APPENDIX A. RUNNING DESIGN CHANGES/FIELD SERVICE BULLETINS

The factory provided these ten Field Service Bulletins to 8X32 dealers and customers. Each Bulletin describes a remedial procedure for a specific problem, or a hardware change necessary to implement an improvement in the machine's design.

URSA MAJOR, Inc.

FIGURE: Install jumper from pin 3 to 4 and to 8.

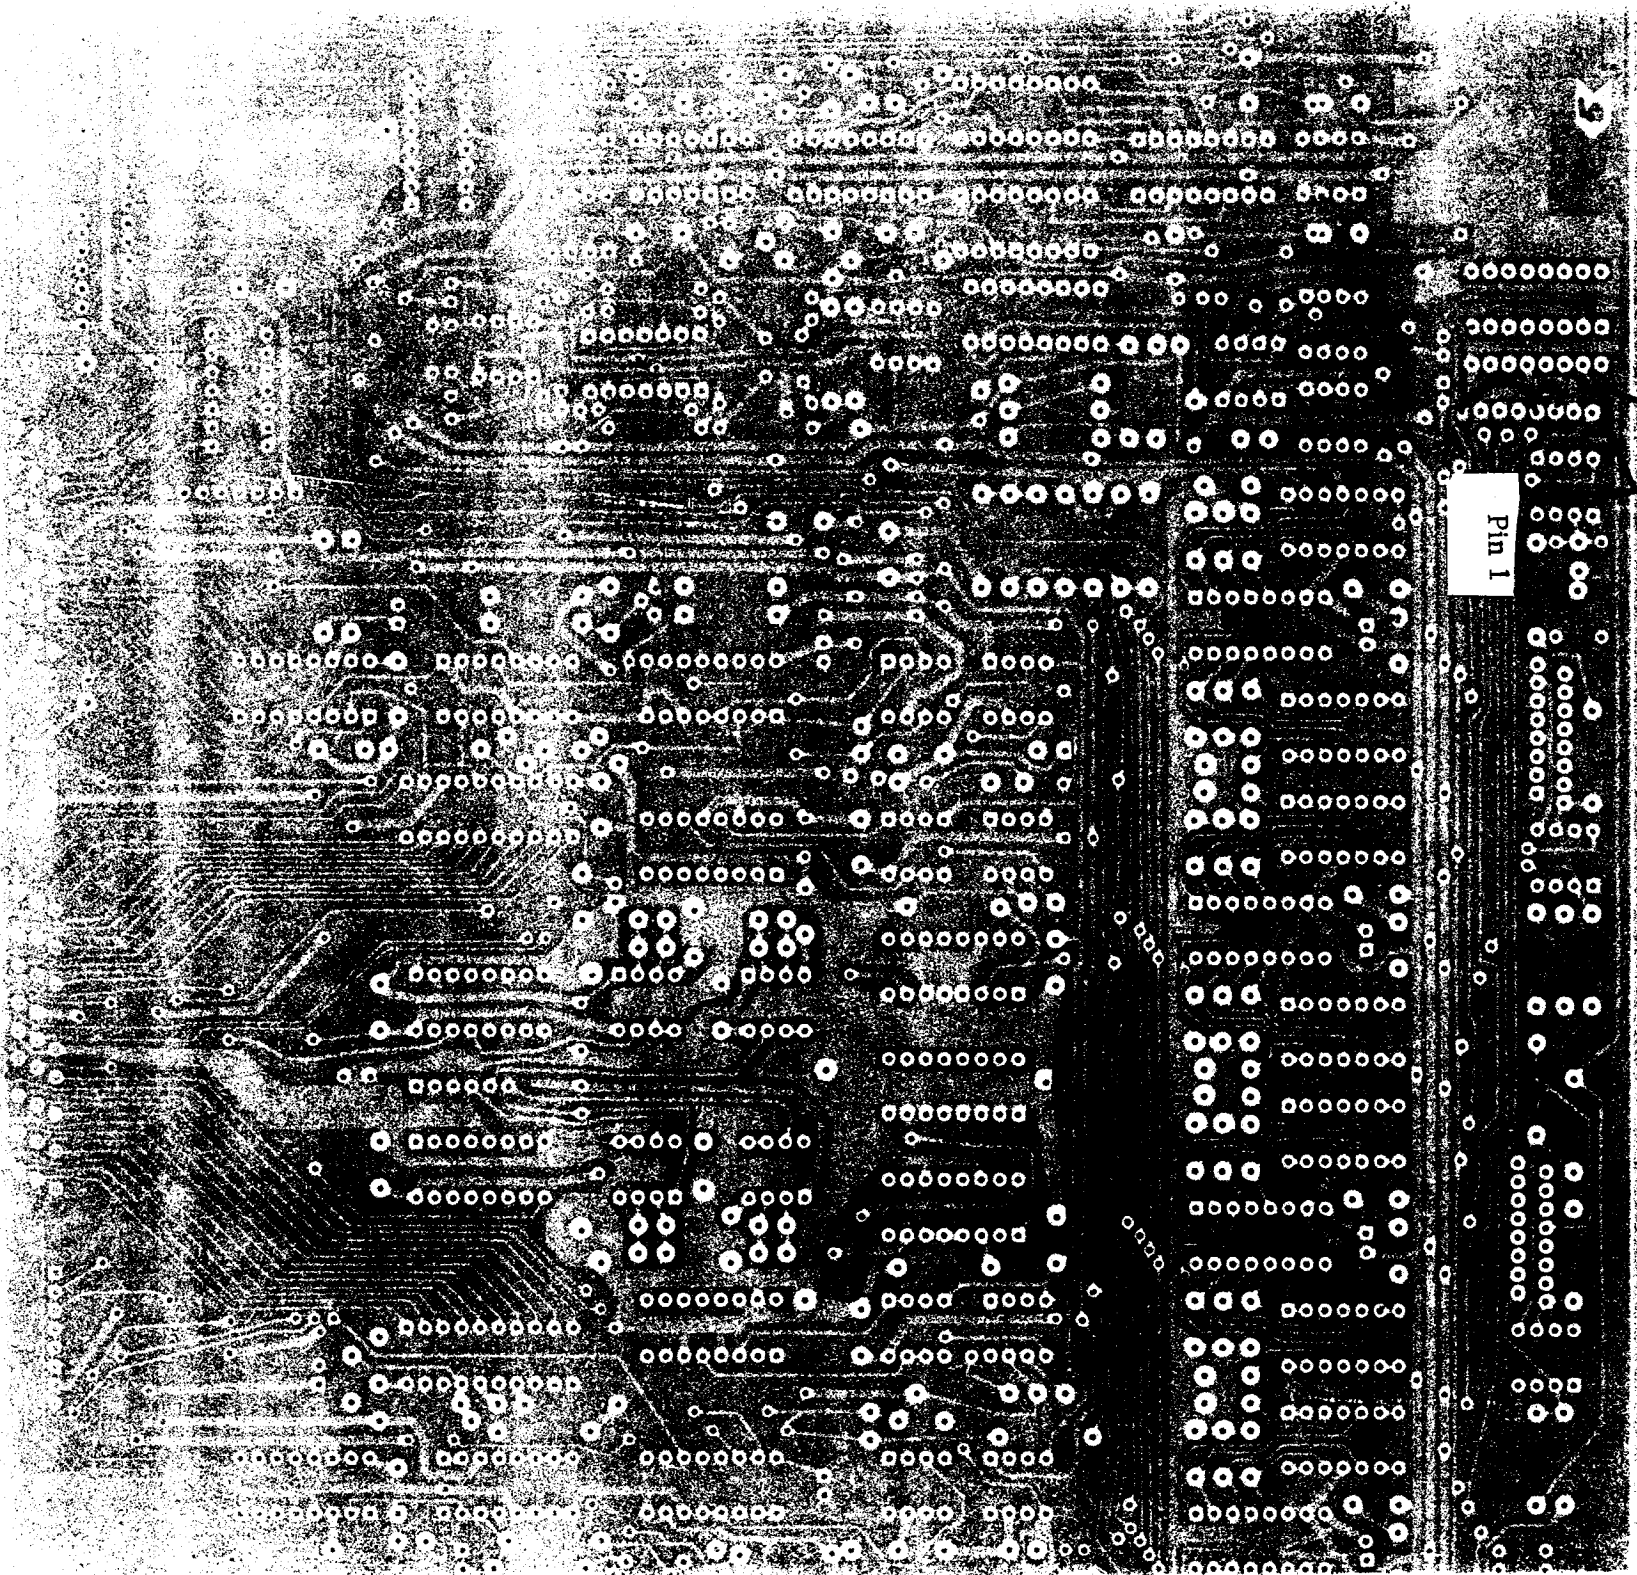
PROBLEM: There is a 3DB gain error in the contribution of three signals going into the reverberator output due to an error failing to ground two resistors.

HOW TO CORRECT PROBLEM: Unplug the power cord. Turn the 8X32 upside down. Remove the bottom cover. Unsolder the three wires going to the connector on the ANA board. Remove all the other ANA connectors except for the three ribbon cable connectors. Remove the three standoffs. Remove the other screws that secure the ANA board except for the two in the front. Carefully hinge the board forward revealing the etch side. At the rear of the board, locate OP AMP U68 and associated components. Right next to U68 is a resistor network labeled RN41. The pin of that network closest to the back of the ANA board is pin 1. Look at the etch side (the back side of the board). At the eight pads for this resistor network, you will notice that pins 2 and 3 are connected to a ground trace. Use #30 solid wire to also connect pin 4 and pin 8 of the resistor network to that same ground point, pins 2 and 3. This will decrease the gain of the stage to signals C2F, C4F and C6F. Refer to the attached figure on following page.

Figure 1 ANALOG BOARD DETAIL: RESISTOR LOCATION
Remove these two resistors

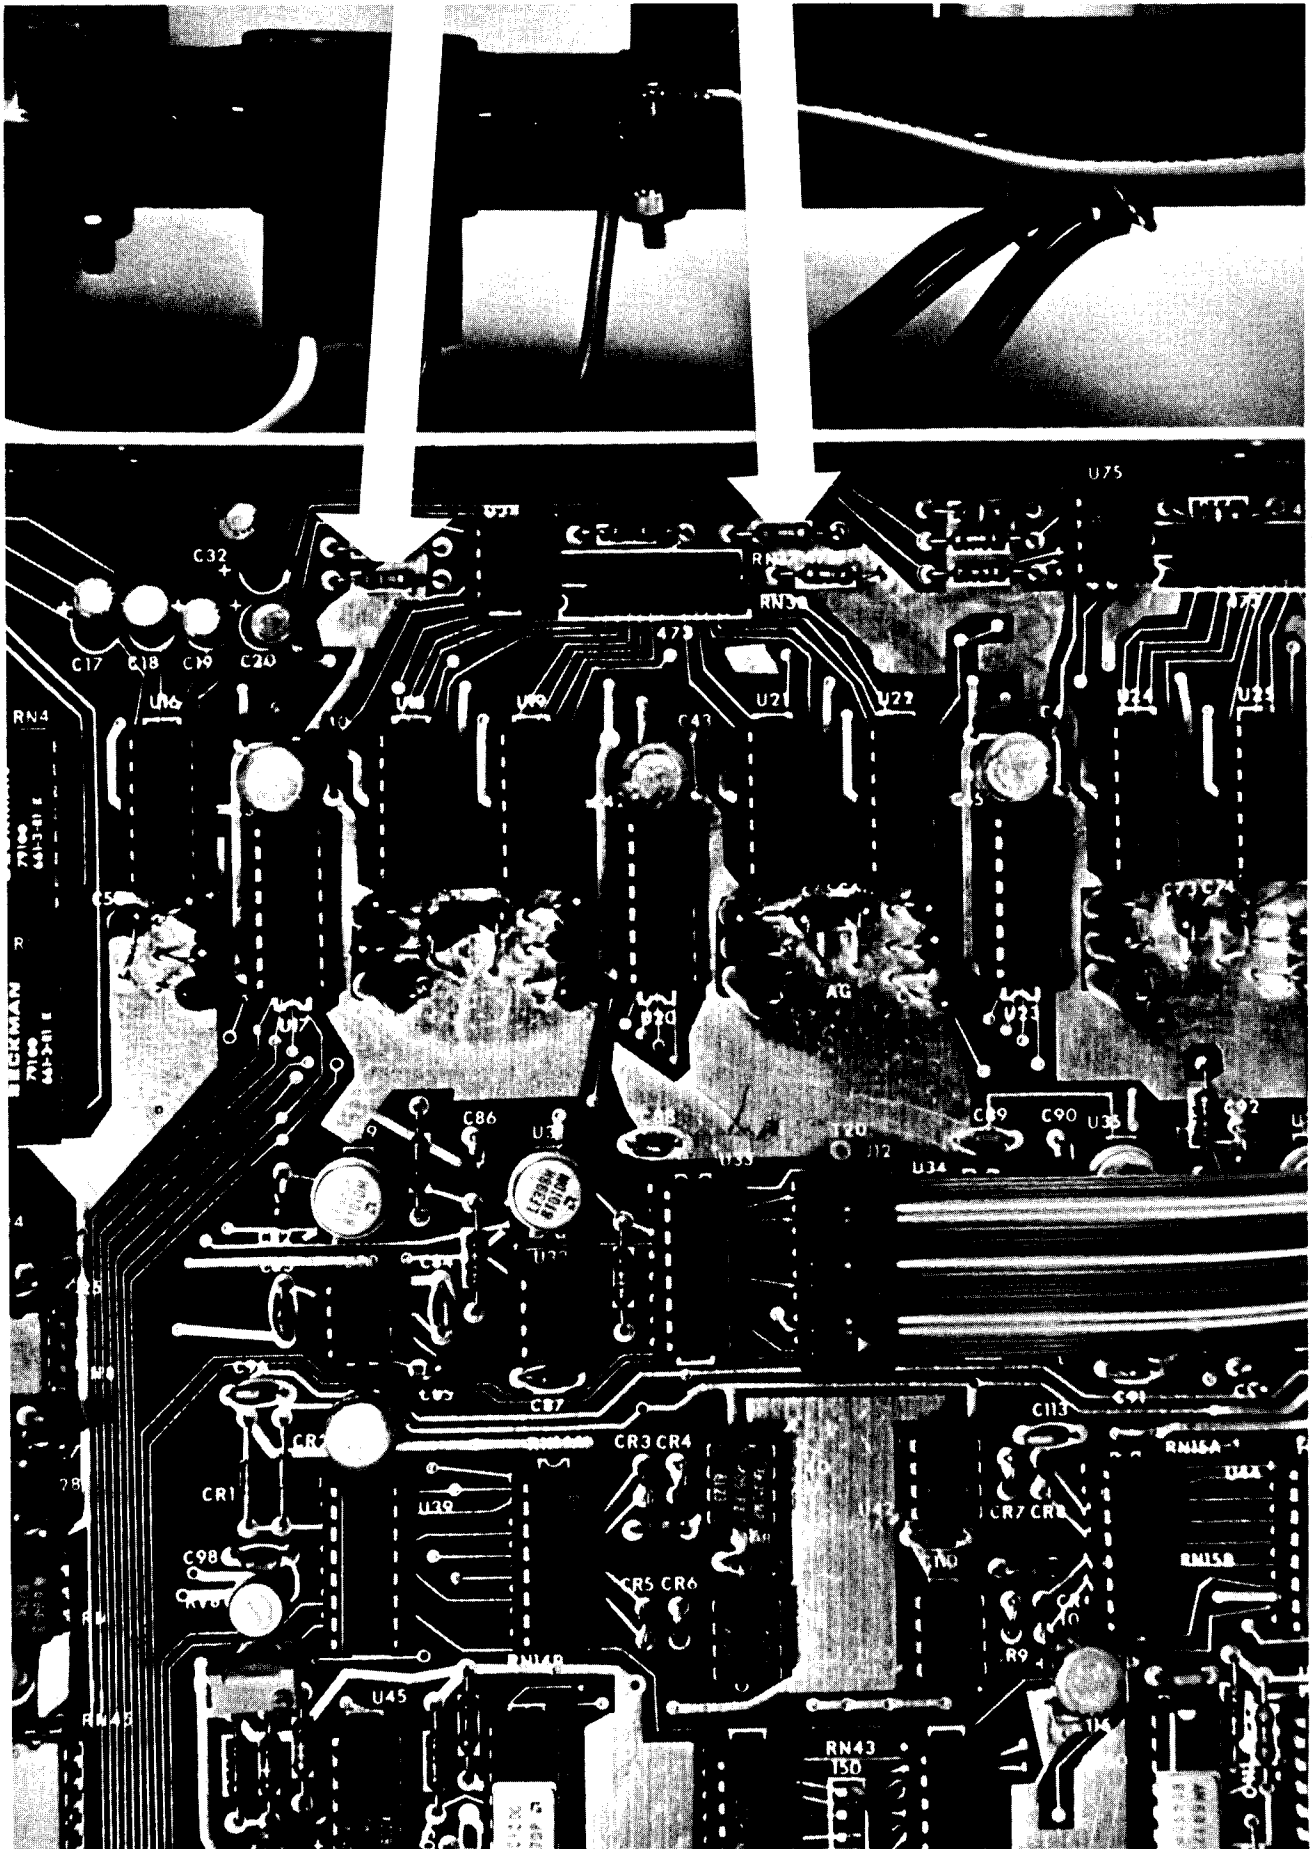
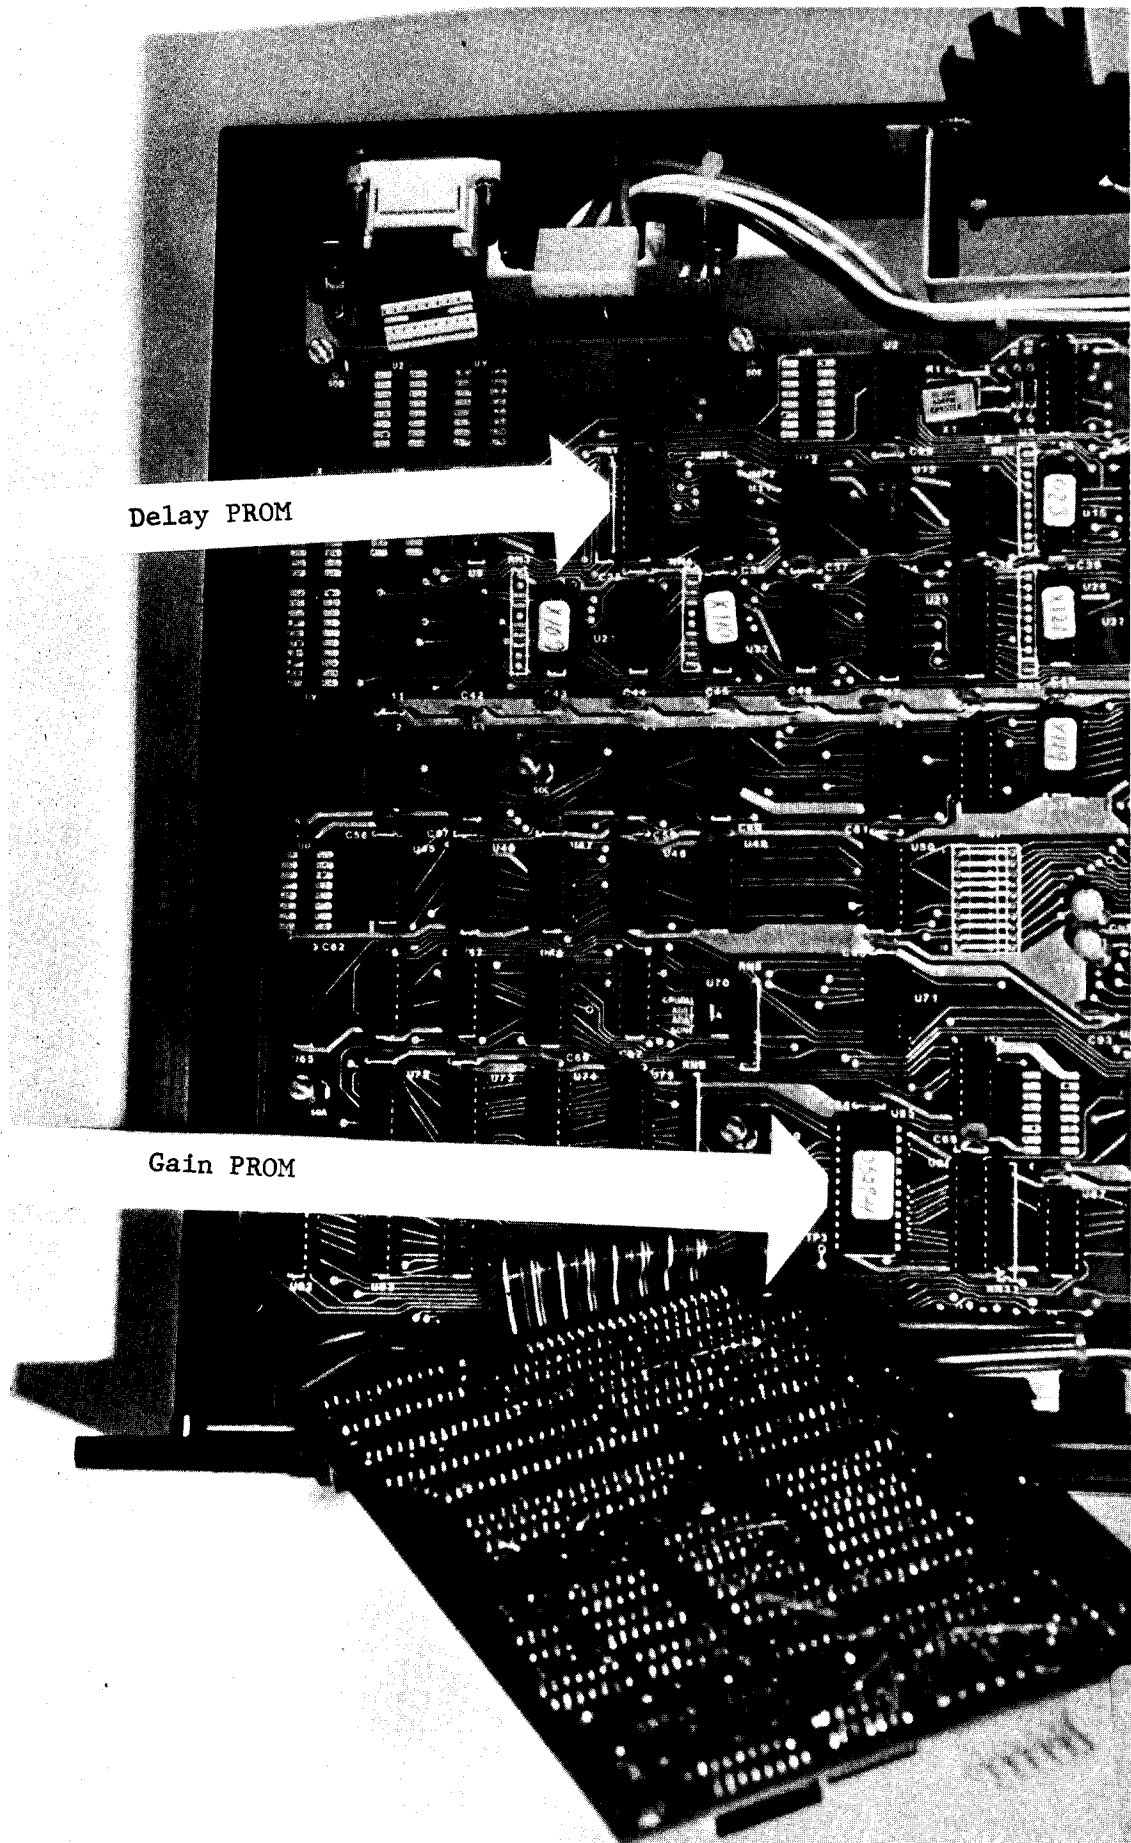
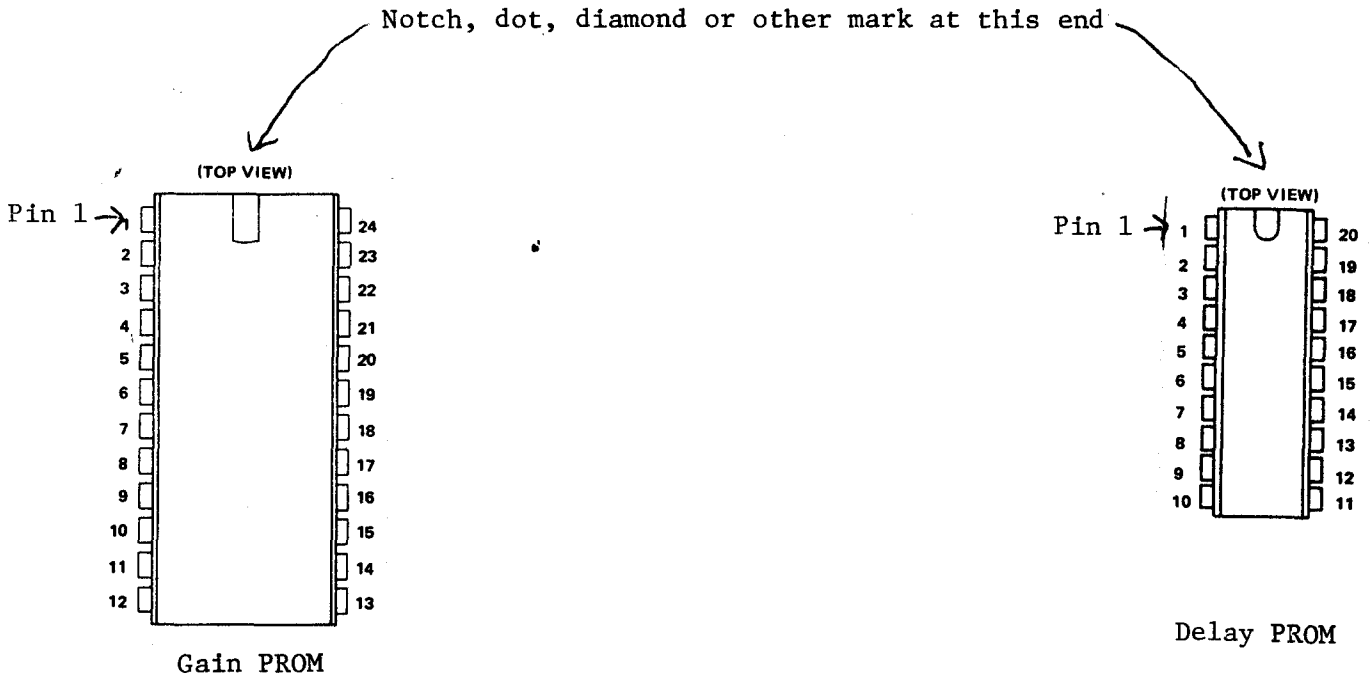
SCOPE OF CHANGE: The programs are completely contained in two IC's. The change, therefore, consists of changing two integrated circuits. At the time of updating the IC's, however, we are asking that two resistors on the Analog board be removed. These two resistors couple out of phase reverberation signals, thus increasing left-right correlation. We have had a number of requests to reduce or eliminate the out of phase signal; removing these two resistors does so completely.

- 1) Unplug the unit. Put it on a padded workbench and remove the top and bottom covers (each cover is secured by 10 small screws).
- 2) Turn the 8X32 upside down on the workbench with the front panel facing you. Refer to Fig. 1 and find the corresponding resistors on the ANA-2 PC board. The left hand resistor (R38) to be removed is color code: red, yellow, orange, gold: 24K. Cut it out with diagonal cutters, being sure that the remaining leads don't short on any nearby circuits. The right hand resistor (R39) to be removed is color code: yellow, purple, orange, gold: 47K. Remove it also. There are no replacement parts for these two resistors; they are completely deleted. This portion of the change eliminates the out-of-phase reverberation.

Change The Delay PROM: Referring to Fig. 2, identify the Delay PROM, the one toward the rear of the chassis in socket position U10. This will either be designated as X116-5, 116-5, 0525-5 or may possibly have no identifying sticker at all. Note the pin 1 end of the IC (toward the rear of the chassis). The new IC must go in just this way. Remove this IC with an IC extractor, or if one is not available, gently pry up each end a little bit at a time using a very small screwdriver. Be very, very certain that when the IC is removed none of the pins have become bent or damaged. Then place the IC in the conductive plastic foam. Next, lift the PROM provided with this kit, Part #0525-6 and check it to be sure that the pins are parallel and straight in both axes. Carefully position the IC with the pin 1 end toward the rear of the unit, the same end where the pin 1 end of the original IC

Change the Gain PROM: Refer to Fig. 2 again to identify the second PROM for replacement. This will be labeled 0527-4 or possibly X124-4. It is in IC socket position U85. As before, use an IC extractor or screwdriver to carefully remove the IC. Replace it, again, carefully referring to Fig. 3 for orientation. Carefully check that all the pins have gone into the socket, that none have bent under the body or splayed out to the side.

Fig.2 PROM Orientation Notch, dot, diamond, or other mark at this end.

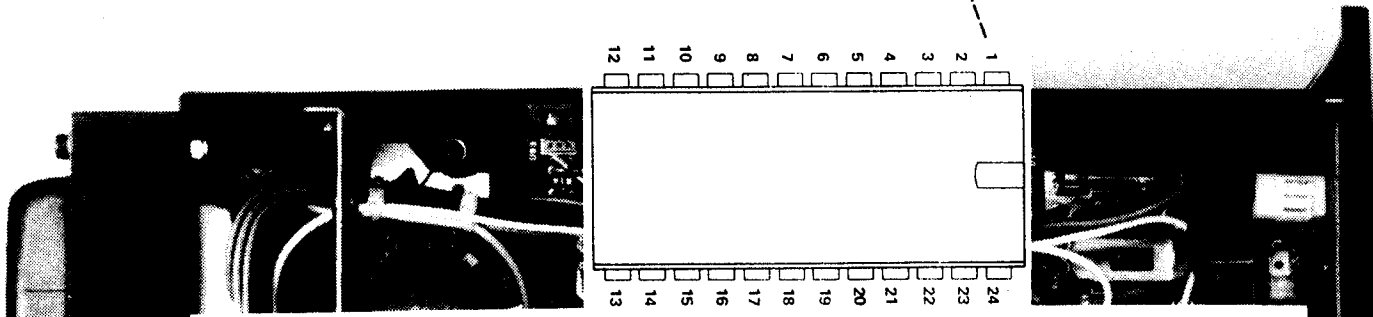
*** You must re-install with pin 1 correct, or you will destroy the IC!
